Amendment Report

Application for Licence Amendment

Licence Number L8579/2011/2

Premises Sunrise Dam Gold Mine

Diagram 1: SDGM sewage treatment process diagram

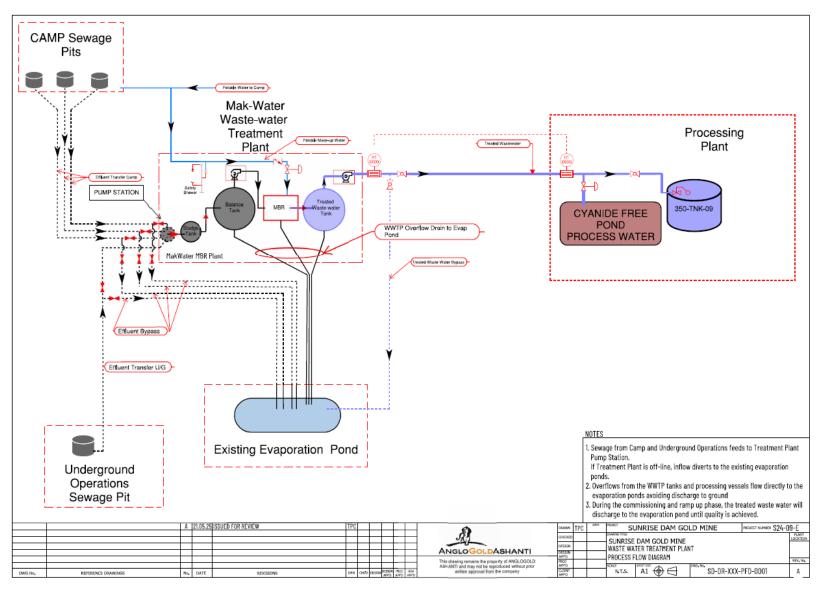
Construction of the MBR includes a concrete slab that will accommodate all components of the MBR. Any potential overflow from the balance tank, MBR or treated water tank will be directed via an overflow pipeline directly to the existing evaporation ponds. The overflow pipelines will be gravity fed to the evaporation ponds and will mitigate the spillage risk in the event of a power failure at the waste water treatment plant.

Condition	Summary of Licence Holder's comment	Department's response
Condition 1, Table 1: Membrane Bioreactor Wastewater Treatment Plant (MBR) concrete pad	AGAA has revised the design of the WWTP. A central sump is no longer included in the WWTP layout design. Any potential overflow from the balance tank, MBR or treated water tank will be directed via an overflow pipeline directly to the existing evaporation ponds. The overflow pipelines will be gravity fed to the evaporation ponds and mitigate the risk of a power failure at the WWTP, as the central sump required a sump pump to transfer any overflow spillage to the evaporation pond.	Design change has been accepted. No change to risk rating as a result. Figures 8 and 9 have been updated to reflect design change.
	AGAA request that the central sump construction requirements are removed from Table 1.	
	Please refer to updated Process Flow diagram - 'Revised Figure 9 – Sewage water process diagram'.
